APPLICATION NO.	FILING DATE	FIRST NAMED INVENTOR	ATTORNEY DOCKET NO.	CONFIRMATION NO.
10/530,691	08/12/2005	Thomas Robert Corbett	ARD124USA	7163
7590 Skinner & Associates 212 Commercial Street Hudson, WI 54016				
04/27/2009				
EXAMINER				
PARADISO, JOHN ROGER				
ART UNIT		PAPER NUMBER		
3721				
MAIL DATE		DELIVERY MODE		
04/27/2009		PAPER

Office Action Summary

DETAILED ACTION

FIG. 3a

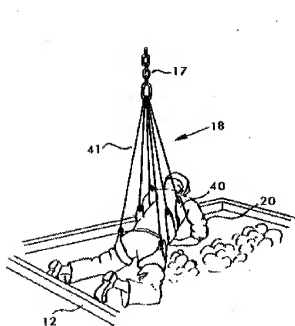
However, Fig. 3a and 3b of MCCLUNEY clearly show that the user is suspended from a chain (17) and is therefore has no constraints on his movement. Further, the user can be clearly seen moving by bending or straightening his legs, thus providing movement fore and aft.

However, while the user’s feet are supported by leg loops, the leg loops only keep the user’s feet anchored to the rear frame member (12) (see Fig. 3a), they do not inhibit the user’s mobility or reduce his ability to bend or straighten his legs, thereby providing movement fore and aft.
